1101 H STREET NE / PUBLIC SPACE PERMIT #380565

FEBRUARY 24, 2022

The following Architectural drawings dated 02.03.22 and submitted to DCRA under building permit #B2109279 are provided to address the open comments for public space permit #380565. Additional dimensions and notes have been added for clarity per the comments below, but no changes to the drainage, projections, overhangs, etc. have been made to the building permit drawings.

PENTHOUSE &
PENTHOUSE ROOF

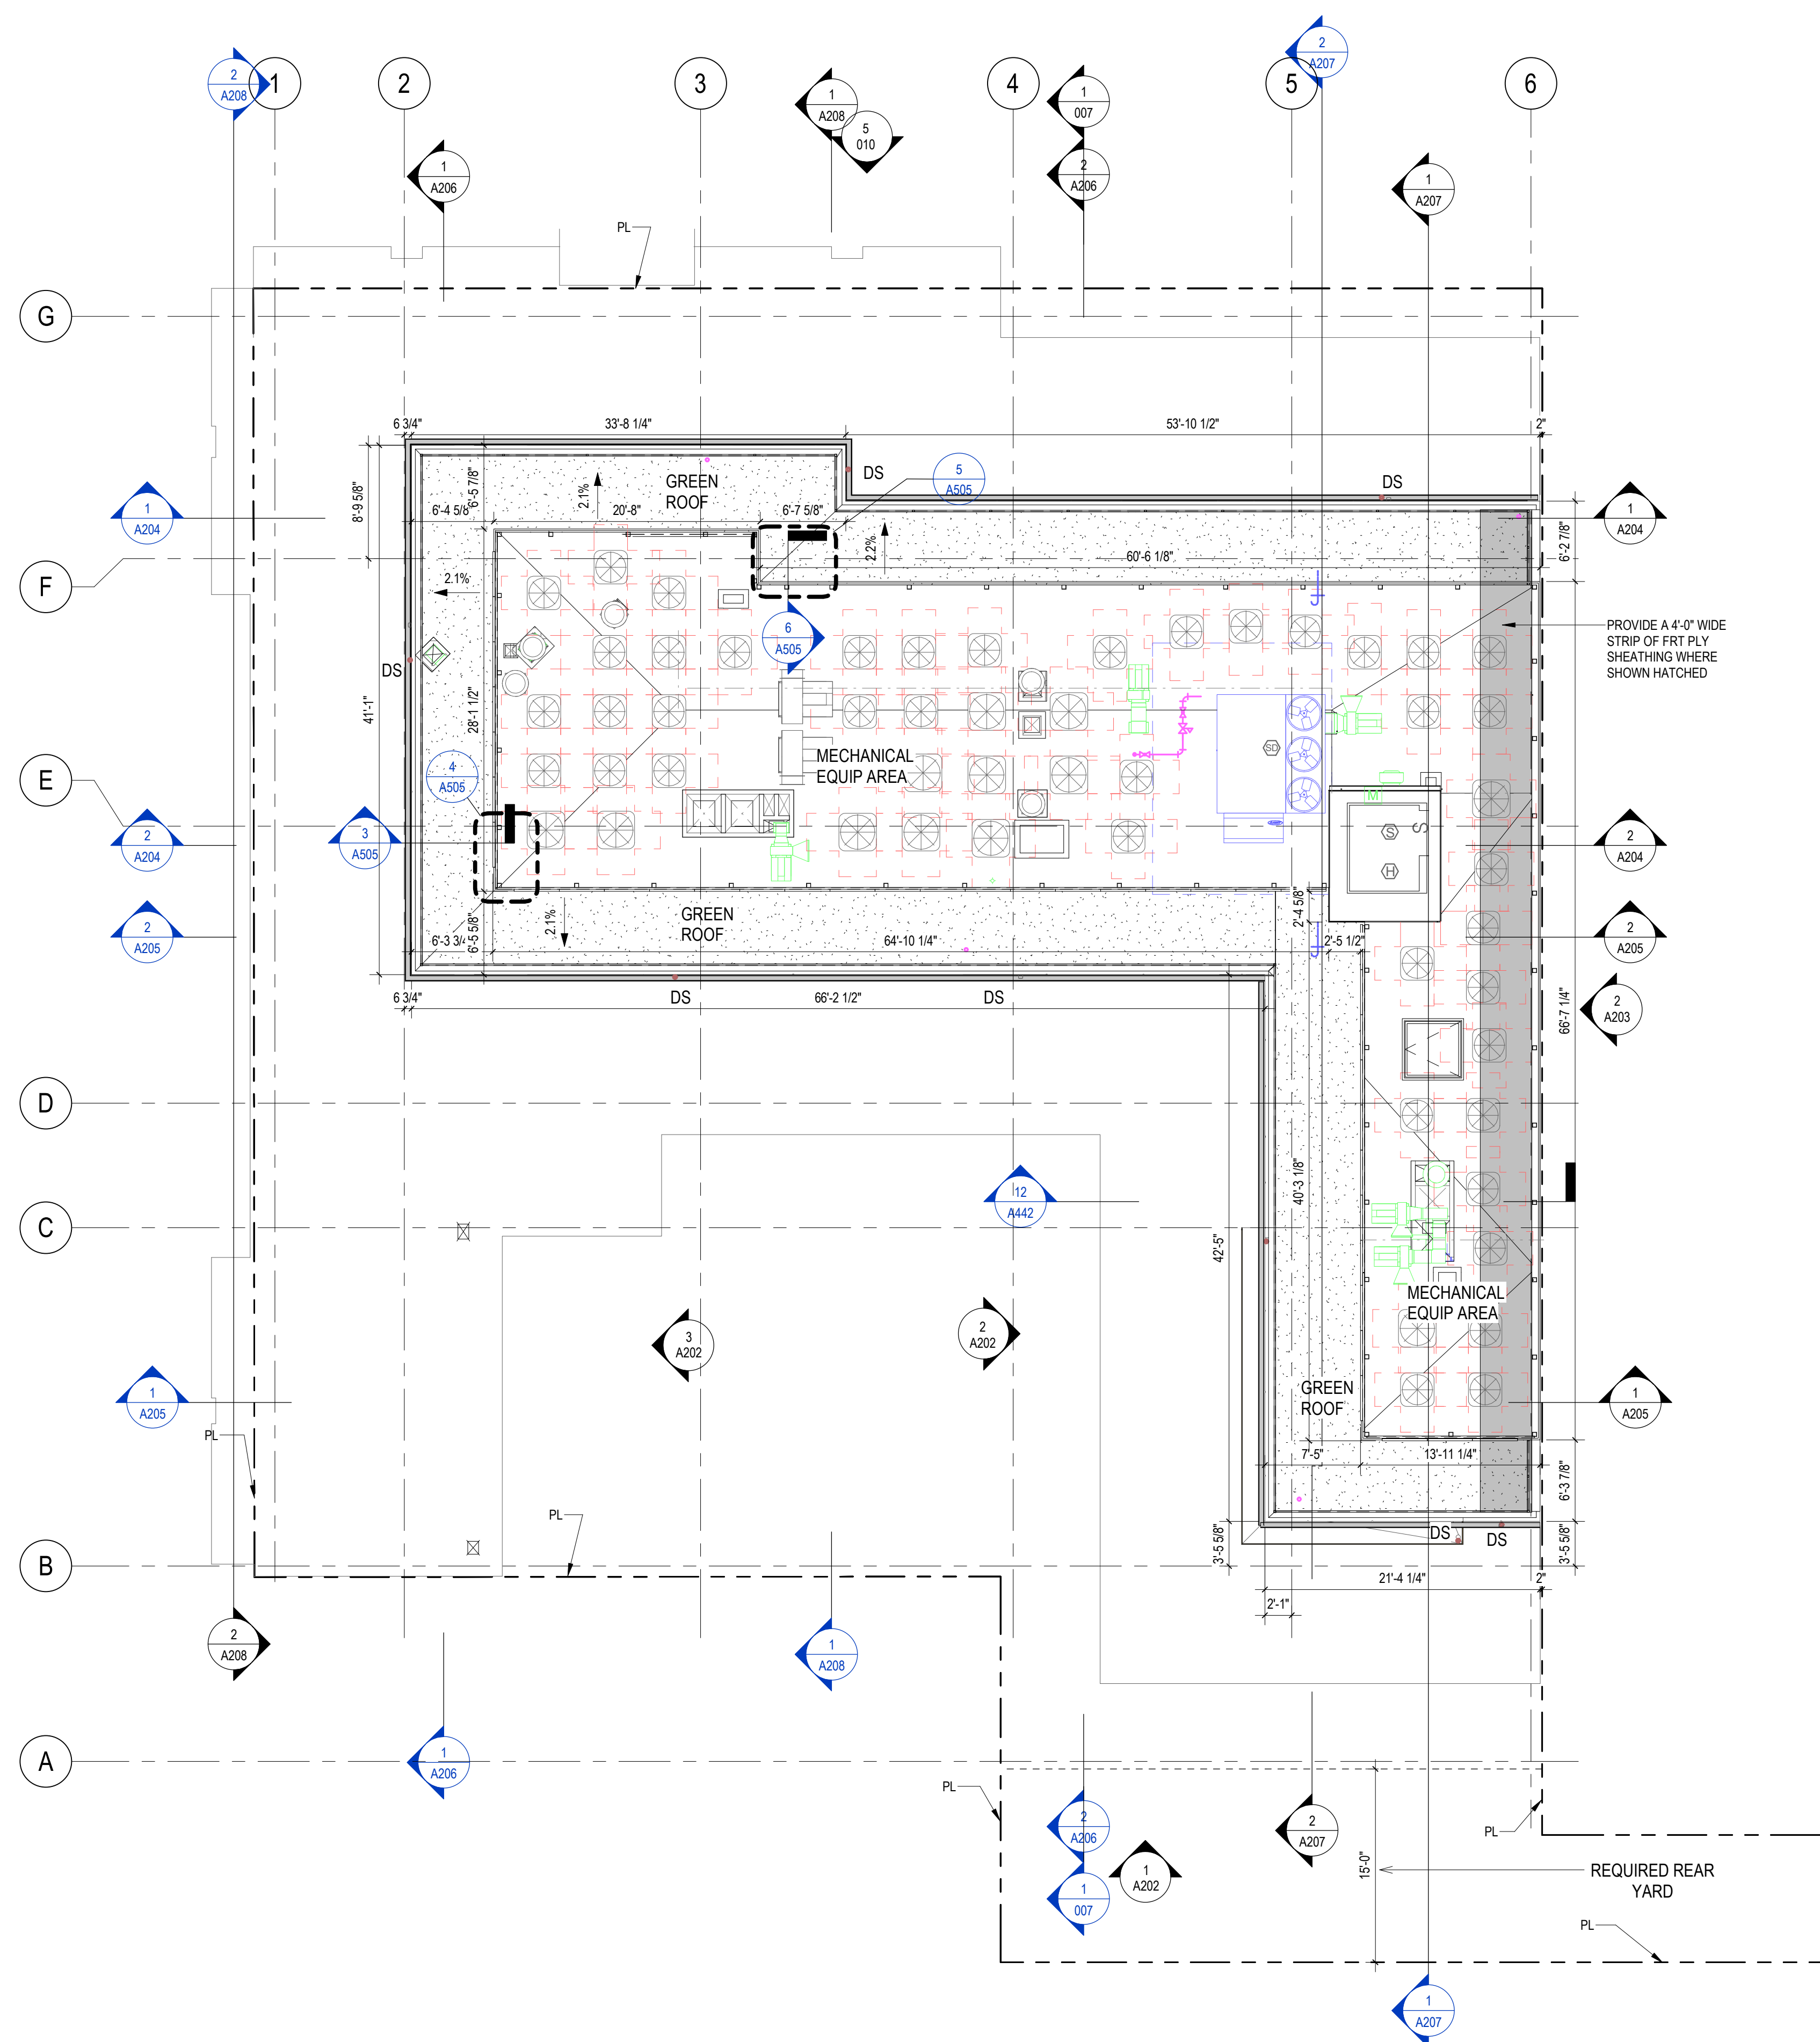
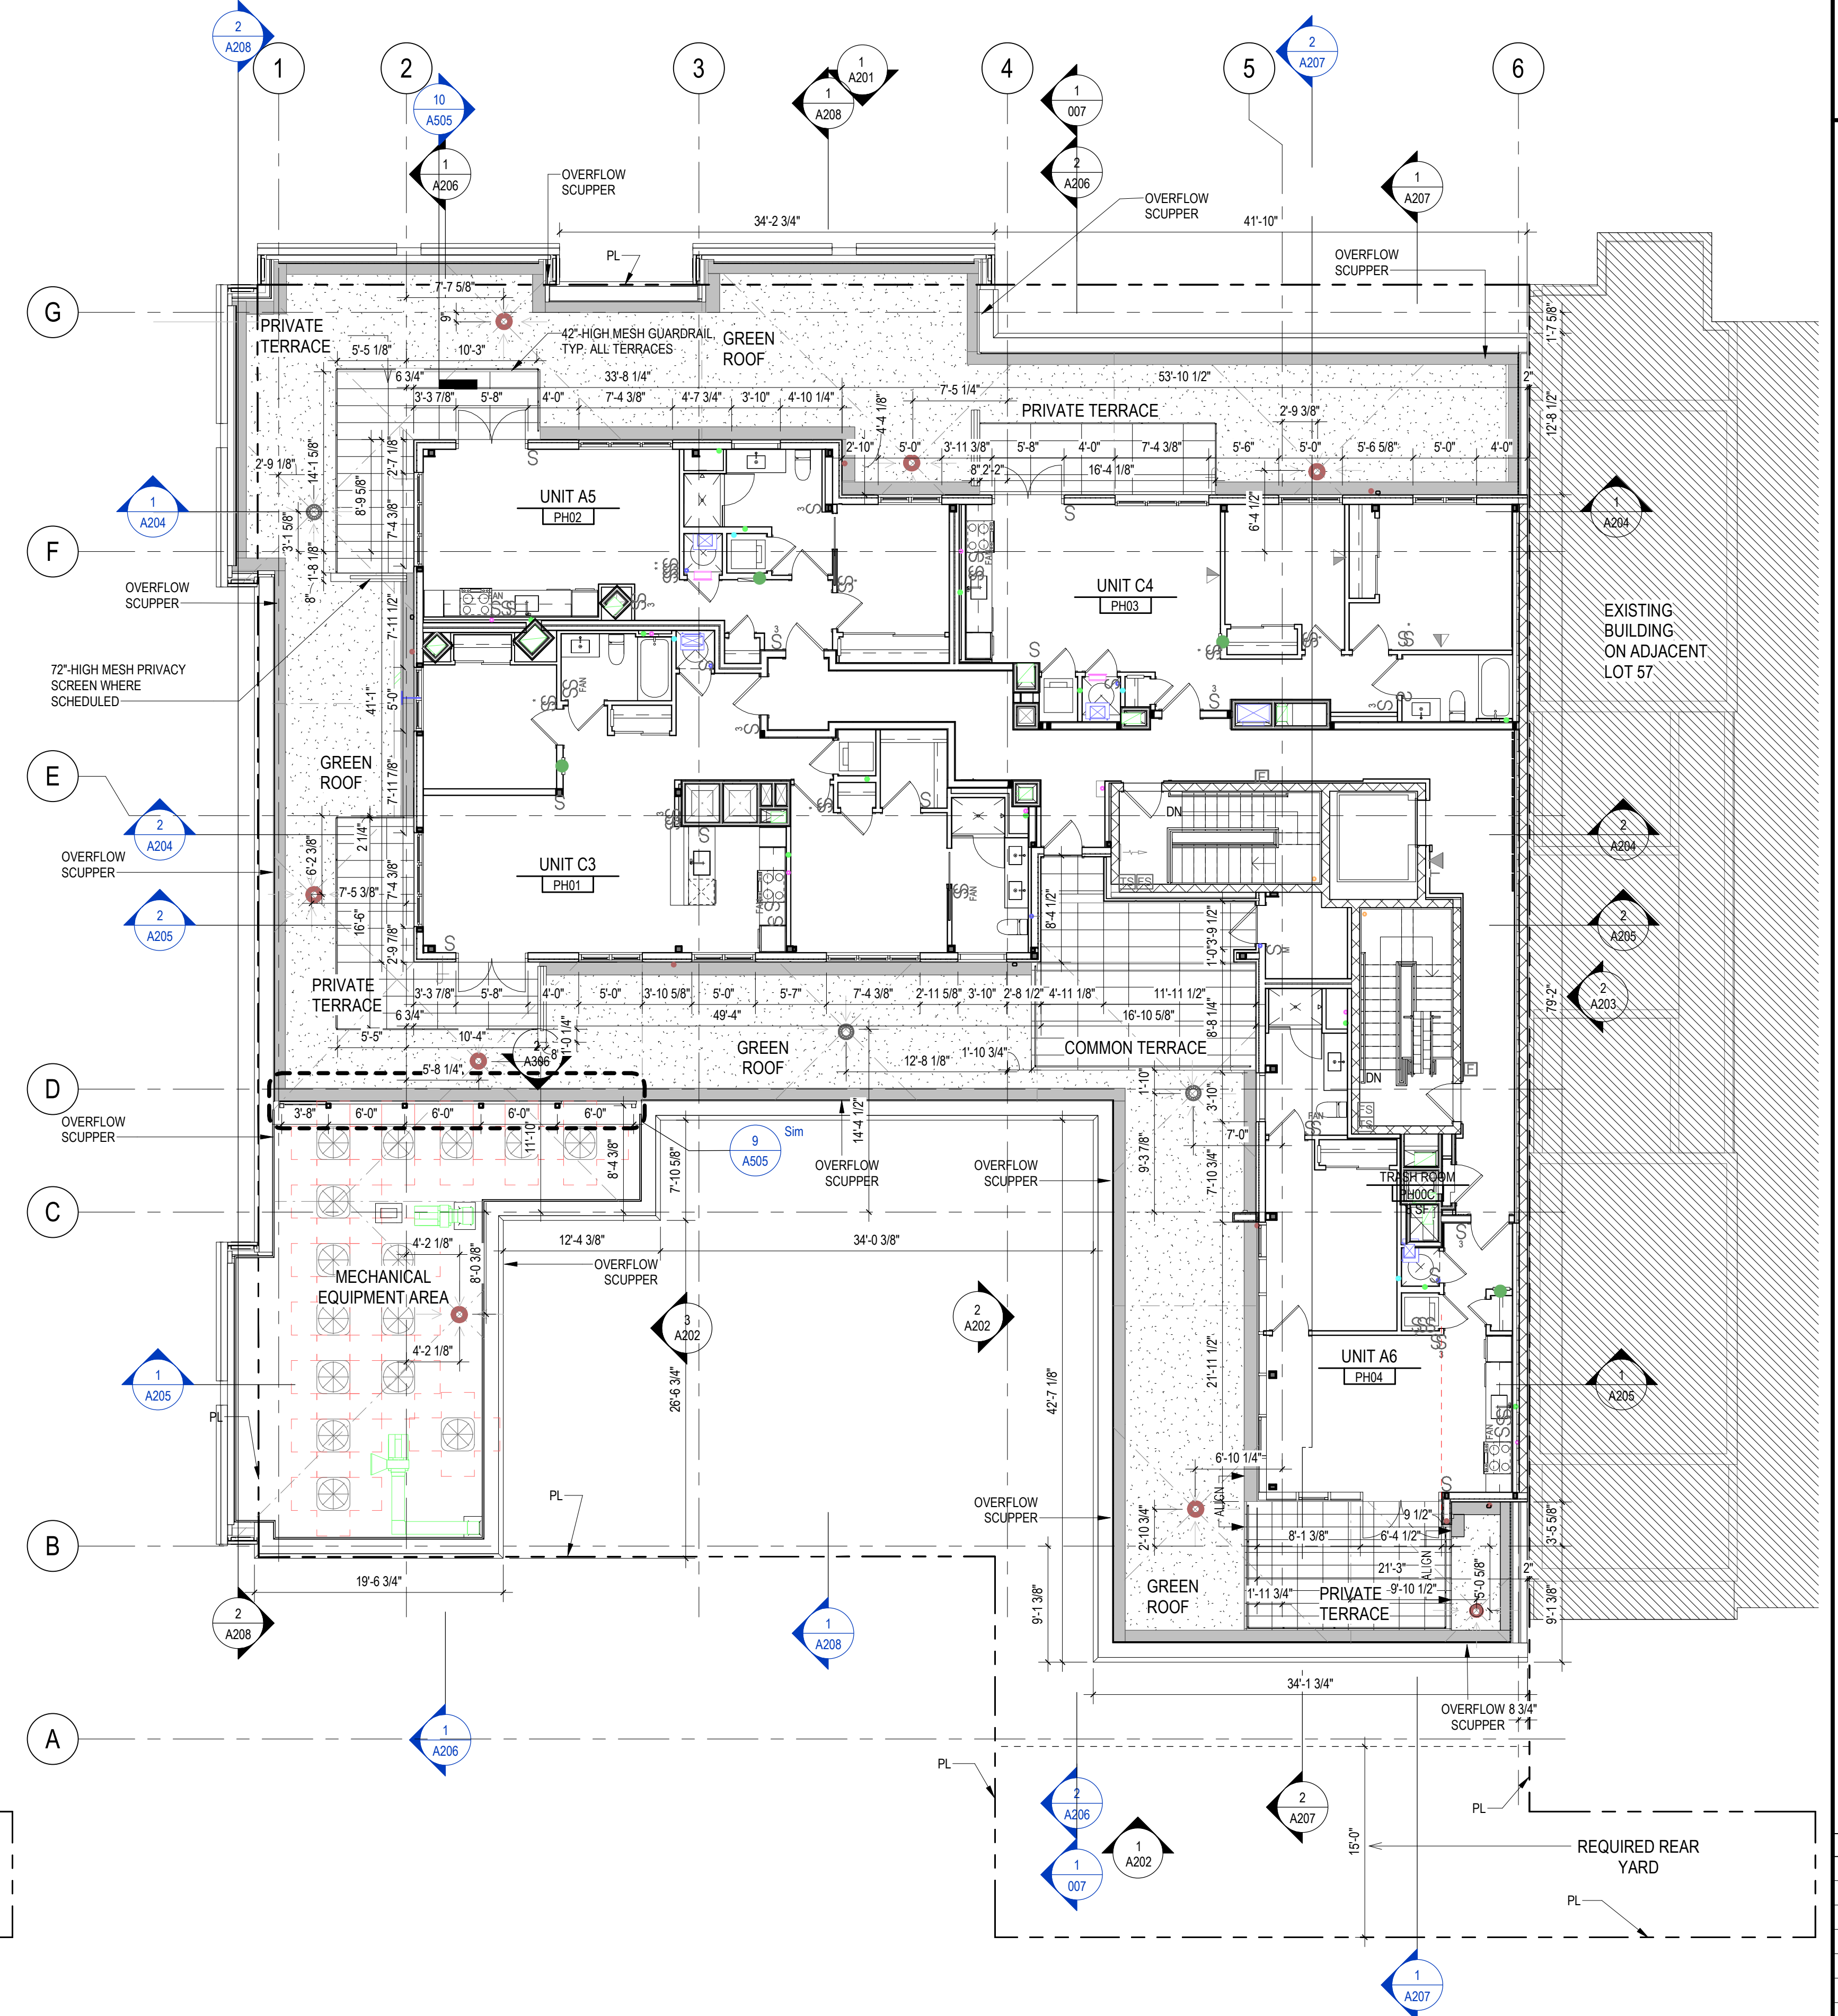
Reviewer	Description	Sheet References
IPMA/ Stormwater	Provide drainage information, including grading, drainage areas, inlets, and downspout locations to demonstrate that no impervious areas drain to the public space.	<p>A102 – 2nd – 6th Floor Plan shows dimensions for the projecting bays. 2ND Floor indicates terrace drainage is internal to property and no impervious areas spill to public way.</p> <p>A104 – Penthouse & Penthouse Roof Plan indicates roof drainage is internal to property and no impervious areas spill to public way. Downspouts from Penthouse roof to penthouse interior drains are indicated.</p> <p>A501 – Exterior Sections indicate impervious canopy drainage is directed to interior of building rather than public way.</p>
OP – Urban Design	<p>Provide additional floor plans that show parking locations and access route, so that OP can fully review the location and design of the proposed curb cut. Curb returns for the driveway must remain within the lot line extended to the curb. Curb returns may not cross over into the public space that is in front of an adjacent property.</p> <p>Please submit elevations, sections, and other relevant details regarding the proposed building projections and overhangs. Per the DCMR Title 12A Section 3202.7.1.1, building projections must maintain a minimum of 12' offset from streets with a right-of-way width of 90', such as H Street NE. Please reduce projecting distance of the proposed bay windows on H Street to maintain a minimum 12' from the curb line. OP</p>	<p>003 – Site Plan indicates dimensions from curb to projecting bay at H Street NE provided as 12'-0 3/8" minimum, and 24'-10 1/8" at 11th Street NE. note: Curb cut at driveway extends past the lot line when extended to the curb due to existing site constraints and is under review with DDOT.</p> <p>A101 – 1st Floor and Cellar Plan shows parking locations and access route.</p> <p>A102 – 2nd – 6th Floor Plan shows dimensions for the projecting bays. 2ND Floor indicates terrace drainage is</p>

Refer to sheet A102, which shows 2nd floor indicates terrace drainage is internal to property and no impervious areas spill to public way. Refer to sheet A104 which indicates roof drainage is internal to property and no impervious areas spill to public way. Downspouts from Penthouse roof to penthouse interior drains are indicated. Refer to sheet A501, which indicates impervious canopy drainage is directed to interior of building rather than public way.
